**Re: PART 573 NOTICE RE MCI G4500 TAG AXLE SWING ARM RECALL PLAN**

Safety Defect and Noncompliance Report Guide for Vehicles  
**PART 573 Defect and Noncompliance Report**

# Service Bulletin No.212

MODEL <b>G4500 Series Coaches</b>	TYPE <b>Field Change Program</b>	SECTION/GROUP <b>2B- Trailing Axle</b>	DATE <b>Dec. 04, 2003</b>
SUBJECT <b>TAG AXLE WELD REWORK</b>			
CONDITIONS

**Figure 4.**

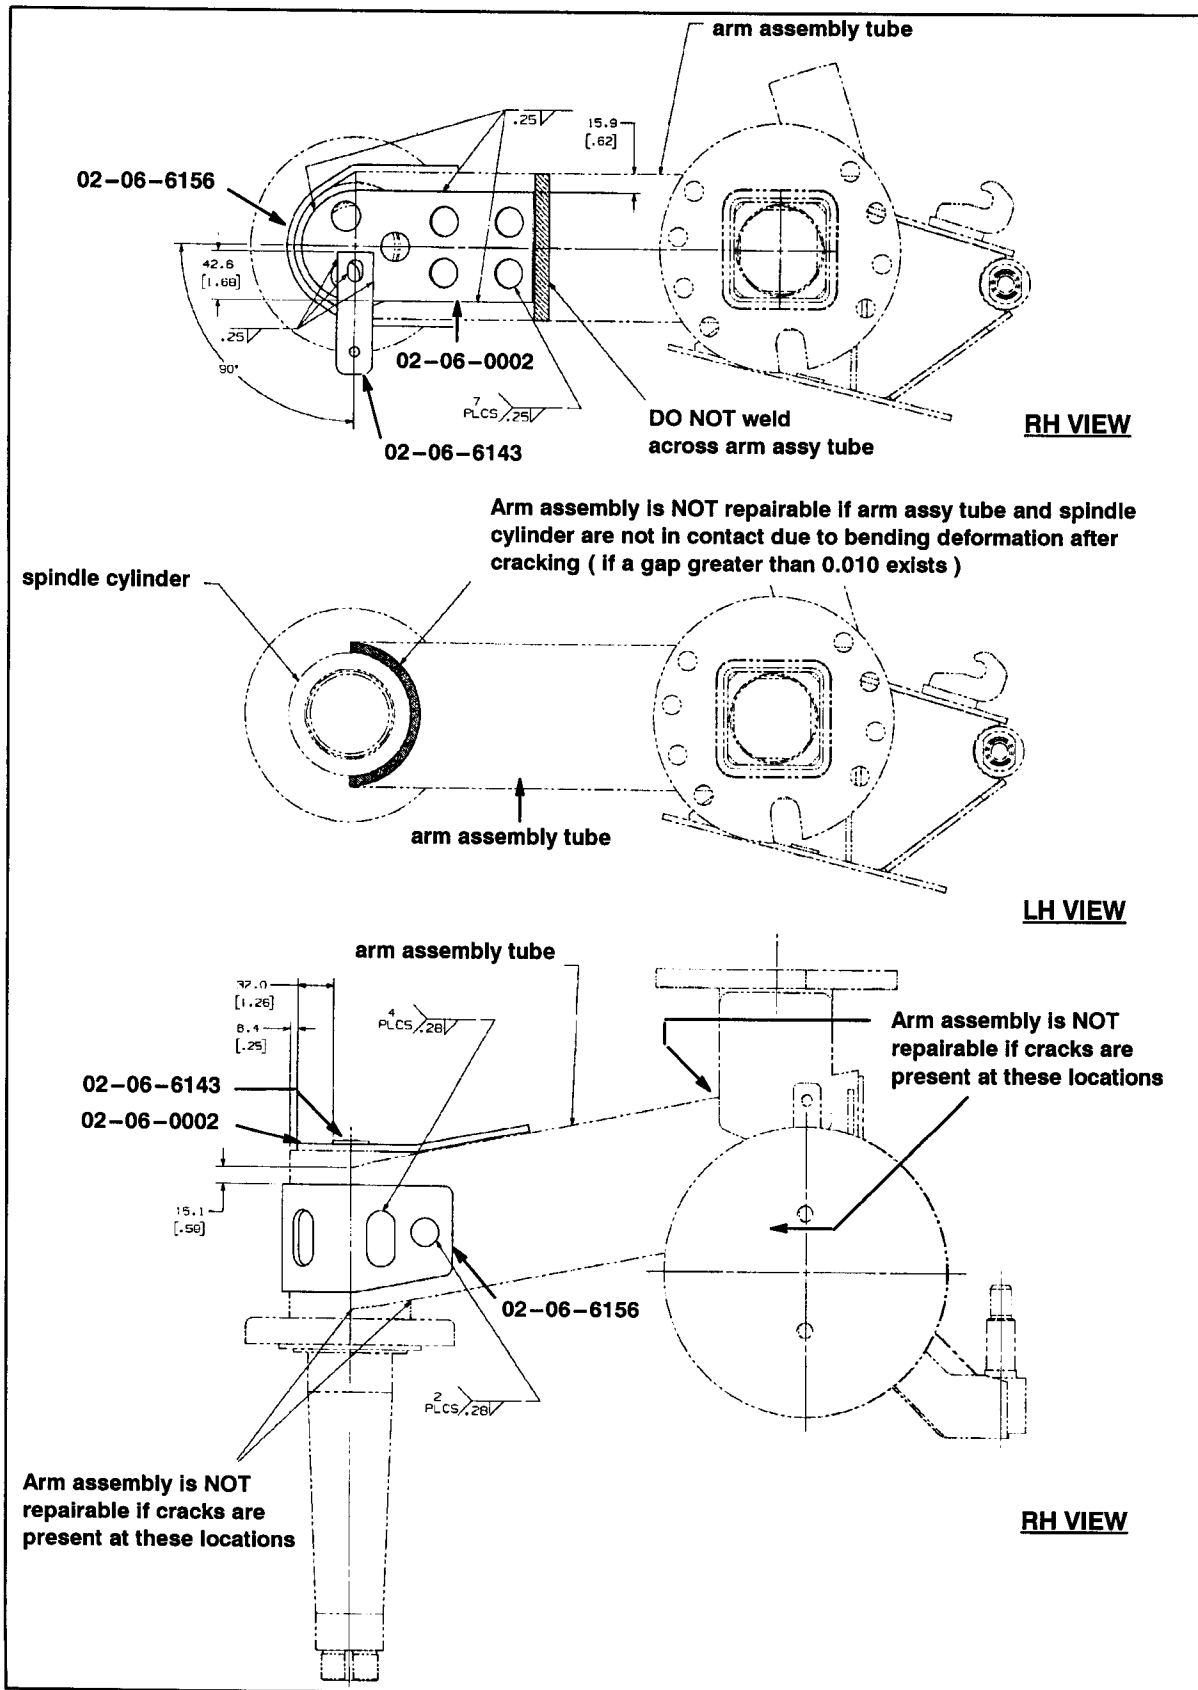
- A. *Cracks propagate thru the arm assembly tube.*
- B. *Cracks are present at lower wheel spindle end of the arm assembly ( Figure 4 ).*
- C. *Arm assembly tube and spindle cylinder are not in contact due to bending deformation after cracks are initiated ( if cracks are more than 0.010 inch ) ( Figure 4 ).*

13. Position the plate ( part number 02-06-0002 ), ensuring that it sits flush and in full contact with the arm tube and spindle ( Figure 4 ).
14. Remove any sharp burrs on the inside edge of the hole in the plate ( part number 02-06-0002 ).

15. Position the plate ( part number 02-06-0002 ) and strap ( part number 02-06-6156 ) in place, ensuring proper fit and installation ( Figure 4 ). Using clamps, secure the plate and strap in position.

16. Preheat the entire assembly to 400 degrees F. Use a temperature stick to verify that proper preheat temperature has been achieved.
17. Weld around inside edge of hole using SMAW process and E7018-1 electrodes ( Figure 4 ).

20. Weld the strap and reweld the brake hose bracket ( removed in Step 12. ), according to welding symbols in Figure 4. DO NOT weld across arm assembly.

21. Perform a visual inspection of the final weld and note any defects that do not meet the requirements of AWS D1.1 Clause 4.8.1.

**Figure 5. Re-worked tag axle arm.**

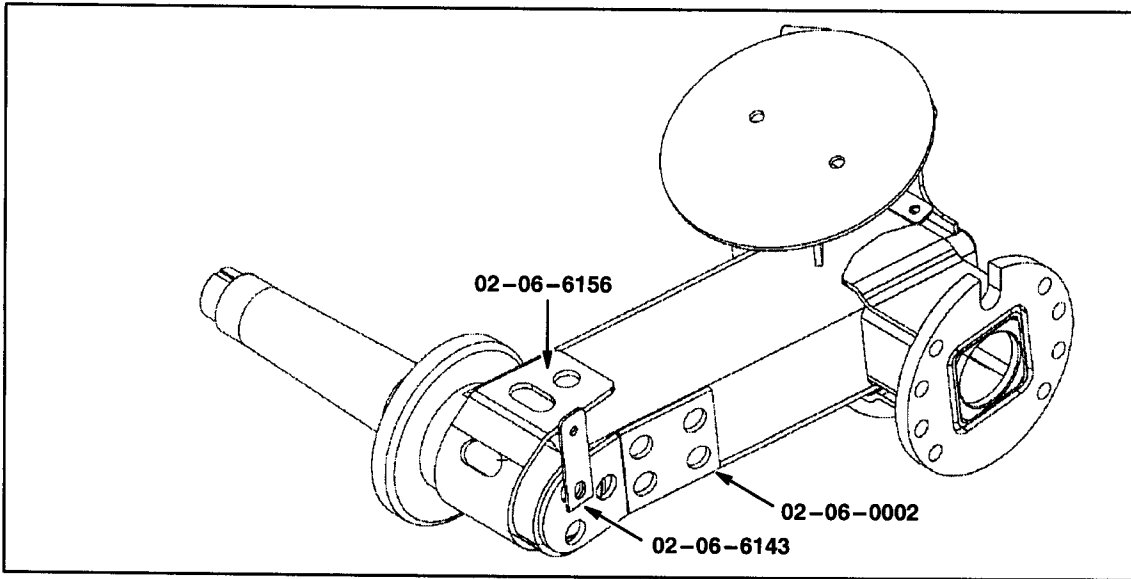
MCI has made design changes to improve the durability and reliability of the tag axle installation. As a result, MCI advises that all G model coaches between the range of unit numbers 80026 to 80518 implement the specified steps in this procedure.

**Figure 9. Re-worked tag axle arm.**

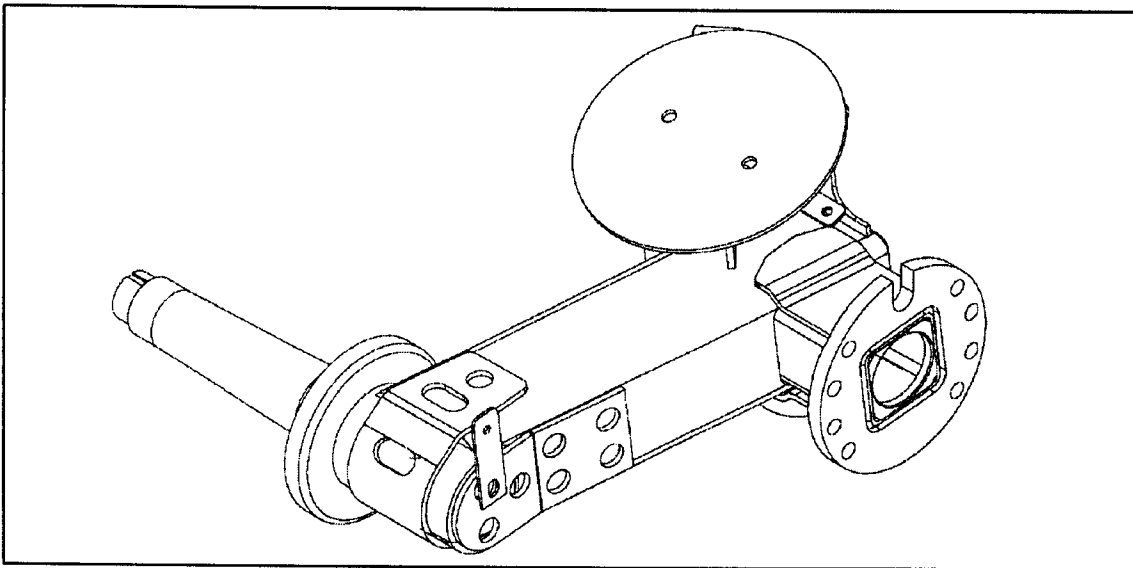
16. Remove the air spring from the existing tag arm assembly. Install the air spring on the re-worked tag arm assembly ( part number 02-06-0001 / 02-06-0003 ).
